STATE OF HAWAII DEPARTMENT OF TRANSPORTATION HIGHWAYS DIVISION MECHANICALLY STABILIZED EARTH RETAINING WALL (MSERW) TYPICAL SECTION AND DETAILS KAHKILI HIGHWAY WIDENING Likelike Hwy. to Vicinity of Haiku Road F.A. PROJECT NO. NH-083-1(26) SCALE: AS NOTED DATE: APRIL 1994 SHEET No. W1 OF W21 SHEETS	
--	--

AS-BUILT ADD. 114

KAHEKILI HIGHWAY WIDENING
Likelike Hwy. to Vicinity of Haiku Road
F.A. PROJECT NO. NH-083-1(26)

PLAN AND PROFILE
R.C. WALL NO. 18

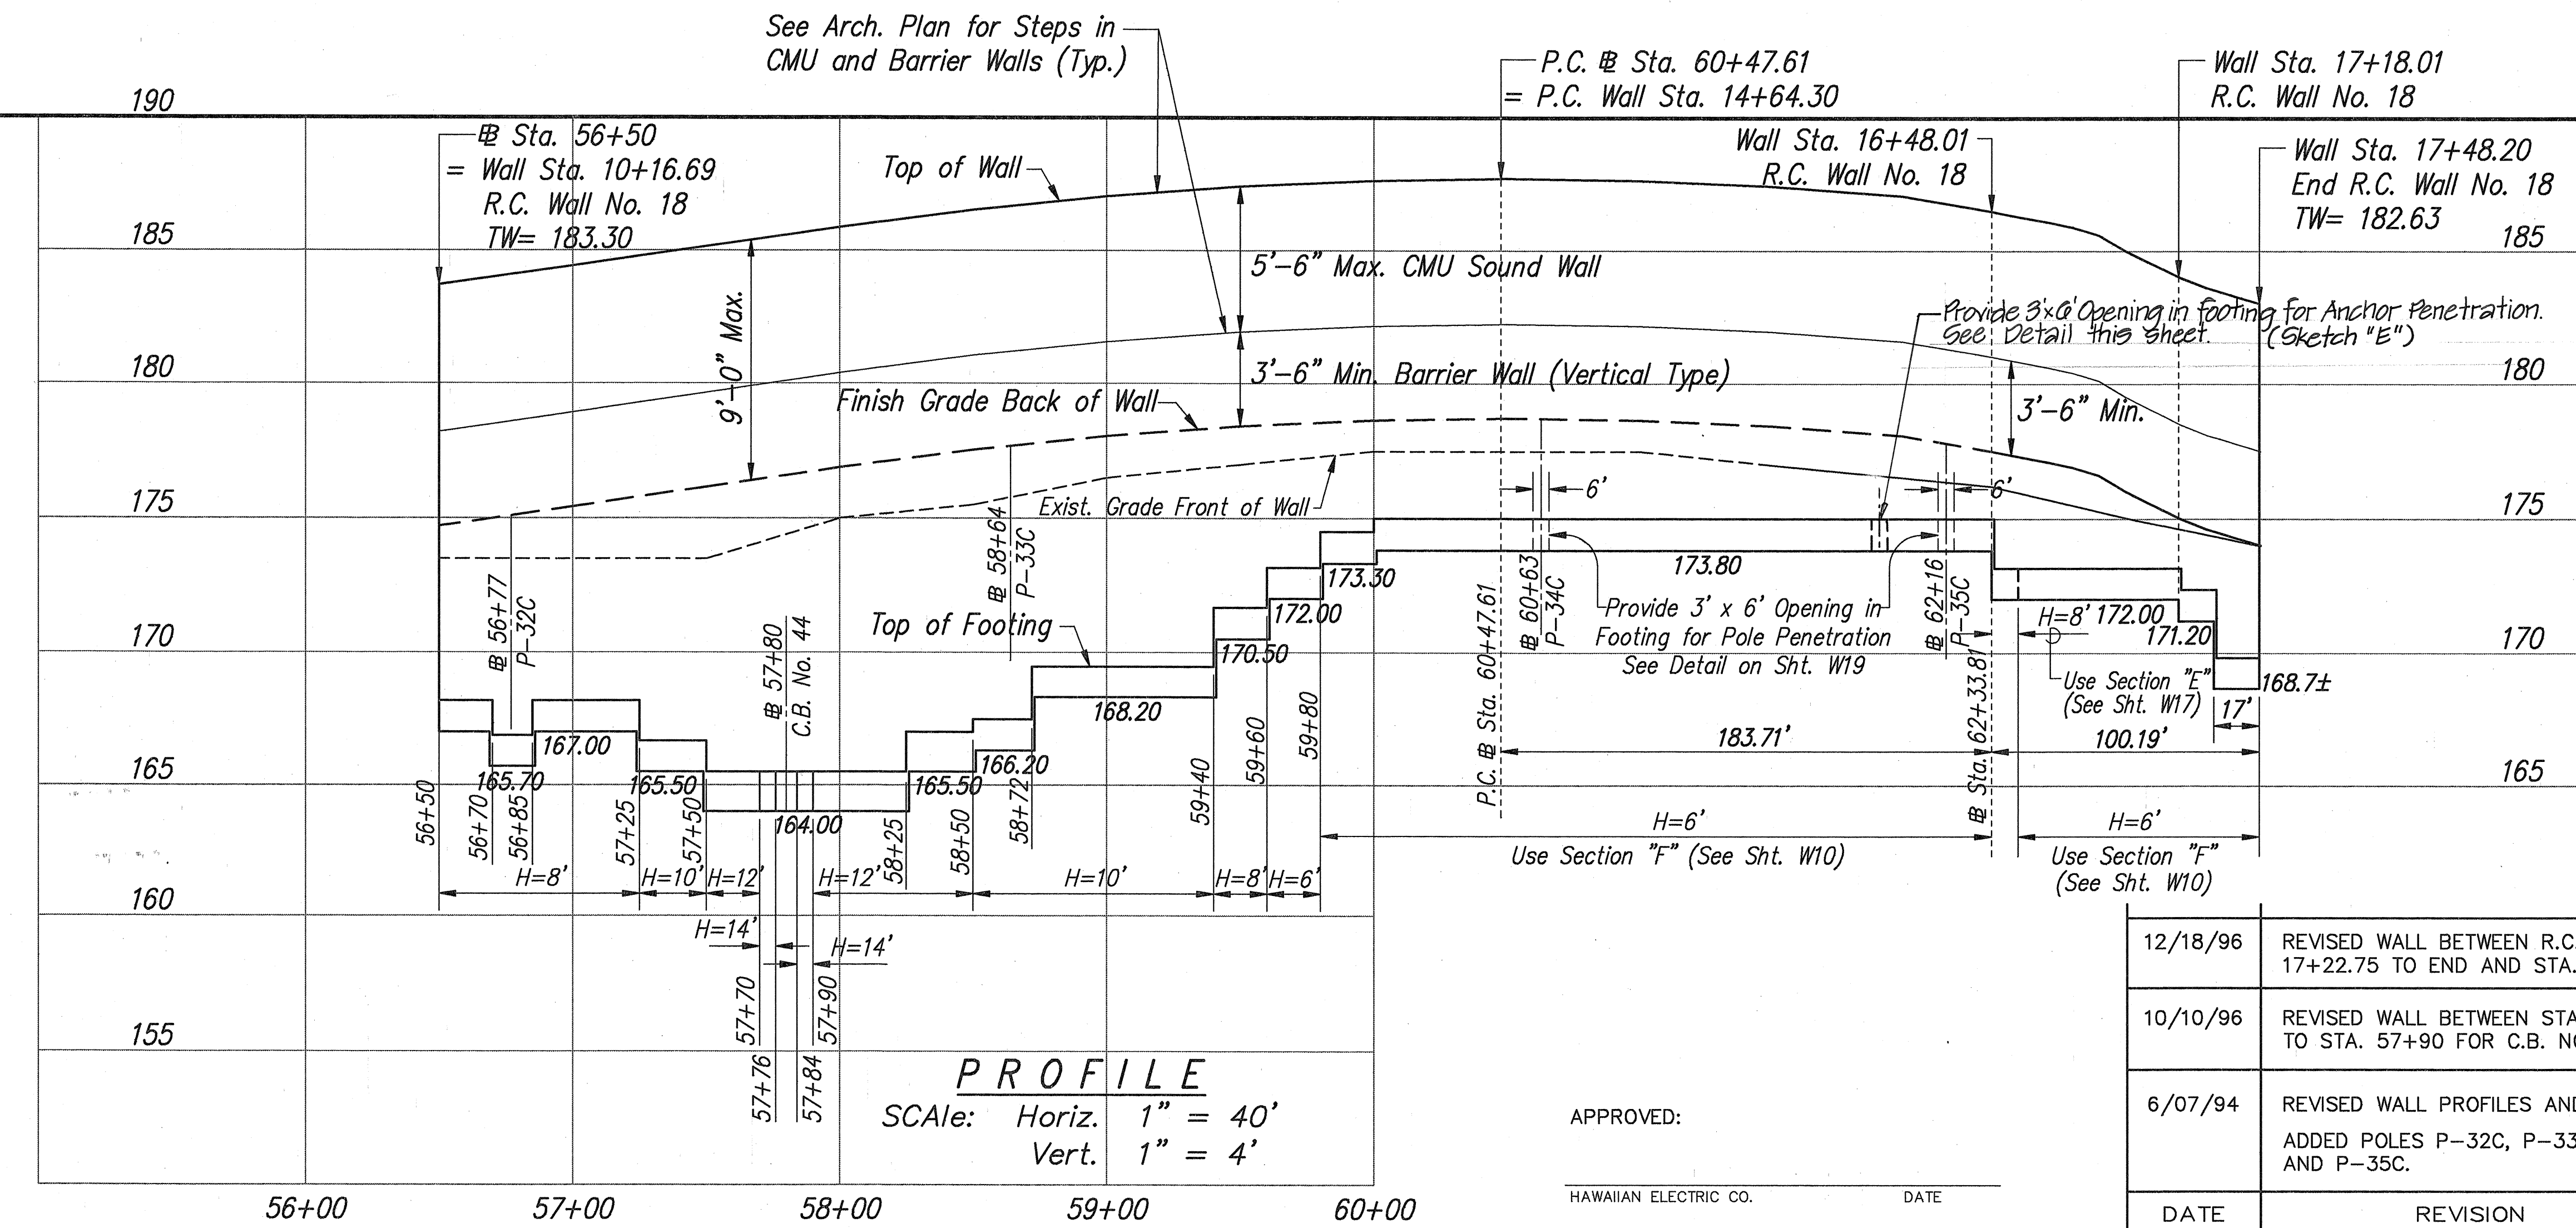
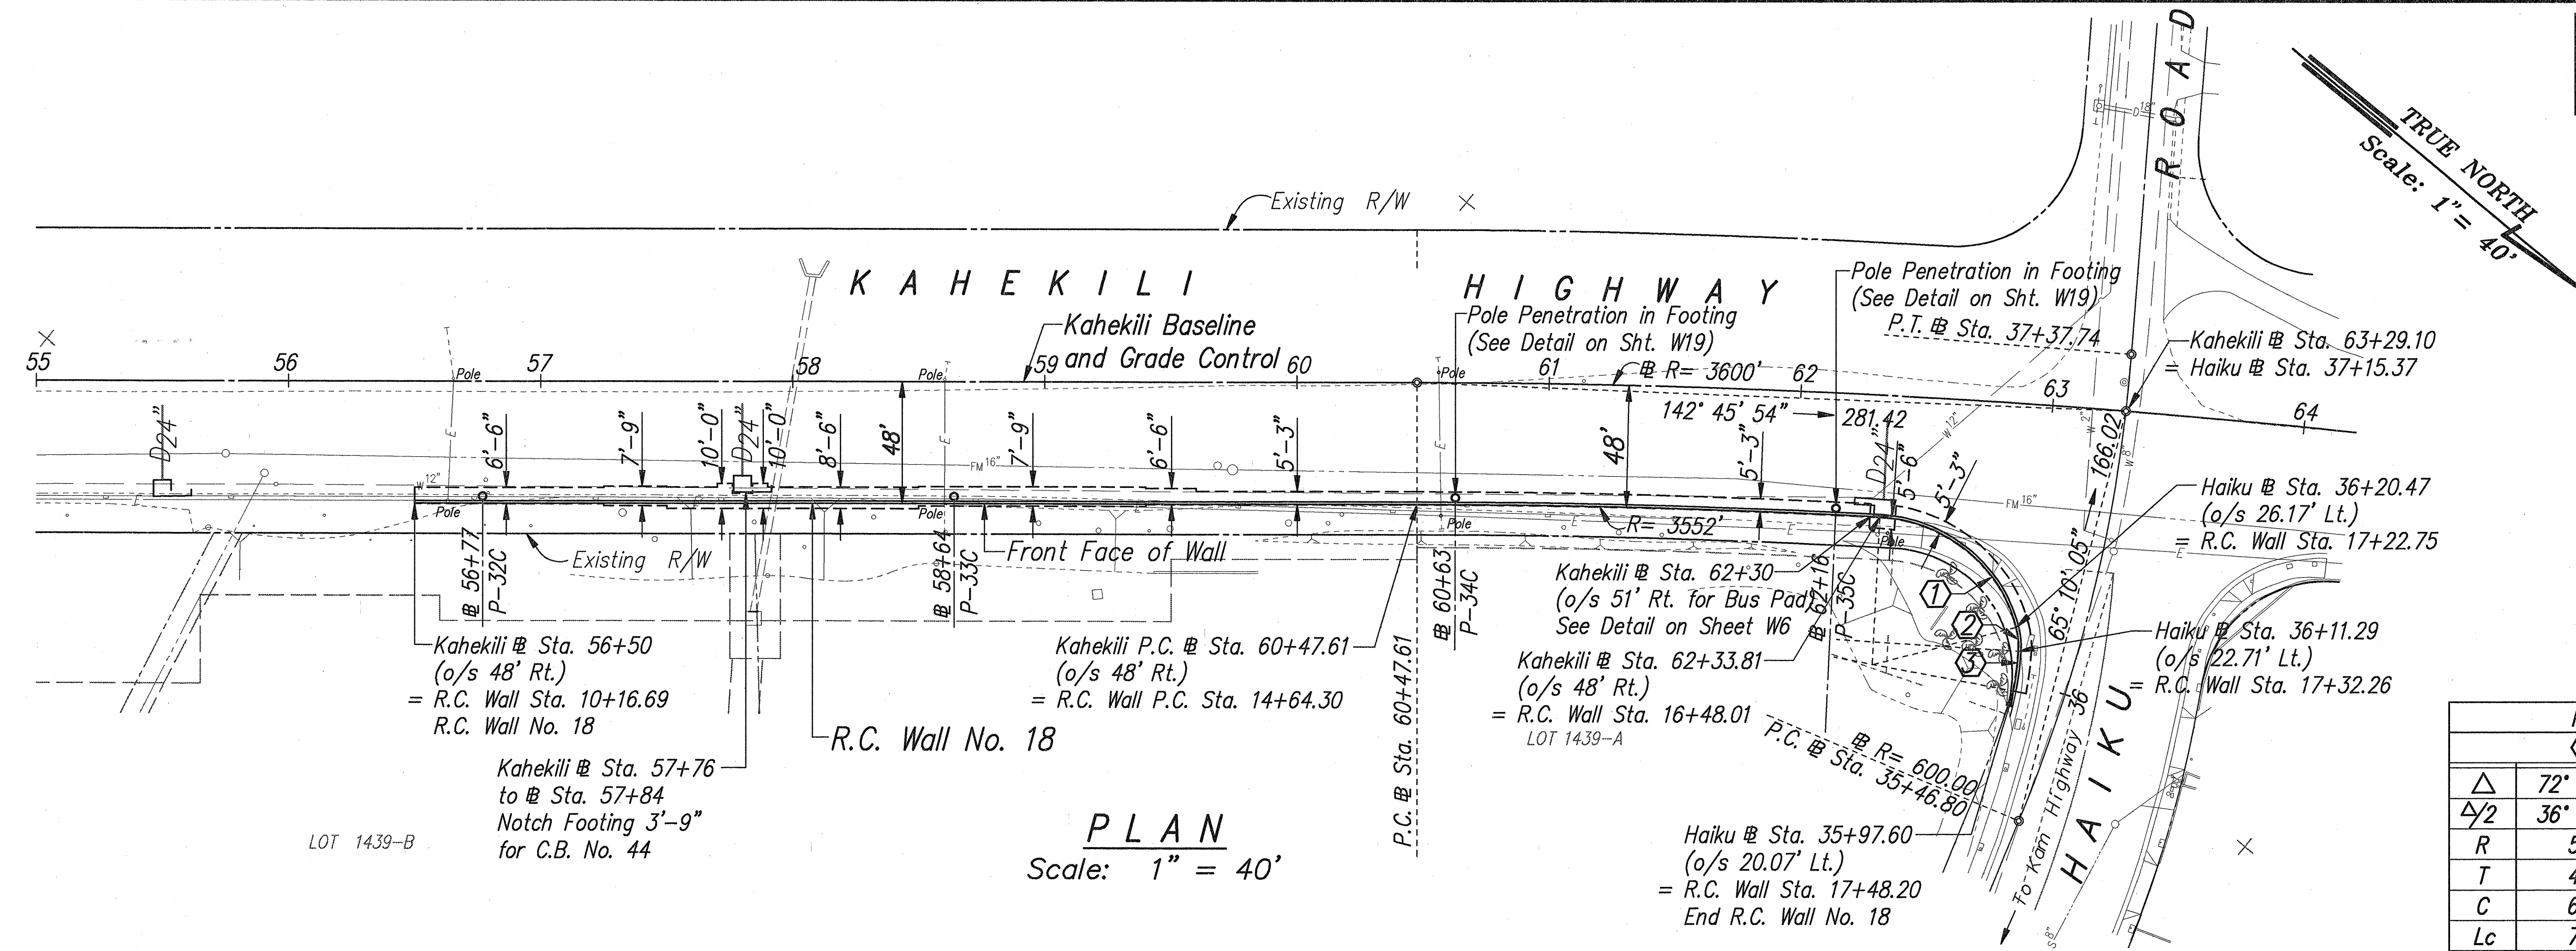
DATE	REVISION
12/18/96	REVISED WALL BETWEEN R.C. WALL STA. 17+22.75 TO END AND STA. 56+50 TWO
10/10/96	REVISED WALL BETWEEN STA. 57+70 TO STA. 57+90 FOR C.B. NO. 44
6/07/94	REVISED WALL PROFILES AND FOOTINGS. ADDED POLES P-32C, P-33C, P-34C AND P-35C.
